REMARKS

In the Office Action mailed May 27, 2004, the drawings were objected to and claims 1-8 were rejected based upon prior art.

APPLN NO.: 10/629,738
Amdt. Dated: September 27, 2004
Reply to Office Action of: May 27, 2004
ANNOTATED SHEET SHOWING CHANGES

FIG. 3

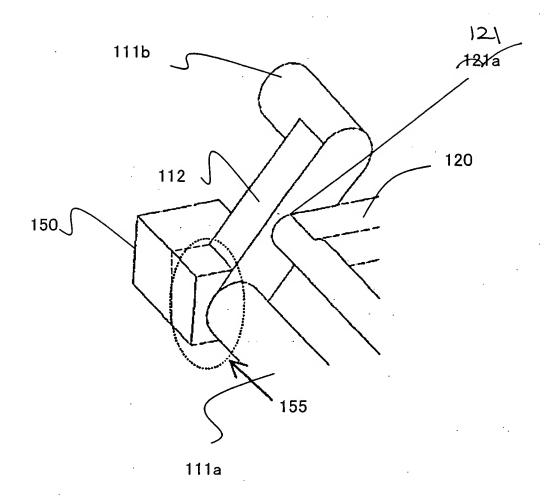
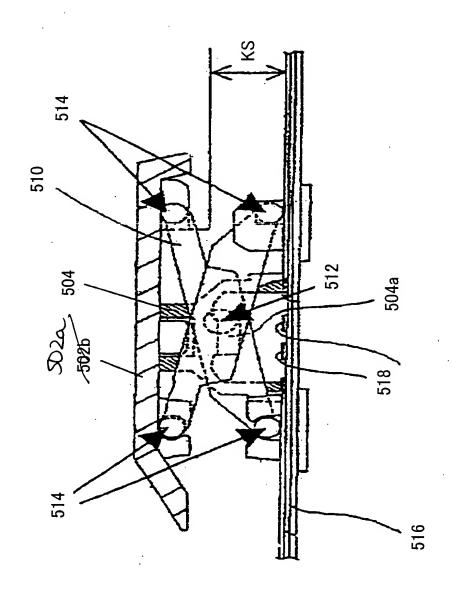
The Examiner has objected to the drawings as failing to comply with 37 CFR §1.84(p)(5) as they do not include reference numerals 502a, 121, and 614 mentioned in the description. Further, the Examiner has objected to the drawings as failing to comply with 37 CFR §1.84(p)(5) as reference numeral 502b is not mentioned in the description.

In order to overcome the above objections, Figure 3 has been amended so that reference numeral 121a is now reference numeral 121 as being consistent with the description provided on page 9. Figure 6 has been amended so that reference numeral 502b is now reference numeral 502a as being consistent with the description provided on page 1. Finally, Figure 7 has been amended to delete the reference numeral 614.

The attached drawings include changes to Figures 3, 6, and 7. In particular, Figures 3 and 6 have been amended to correct reference numerals and Figure 7 has been amended to delete a reference numeral.
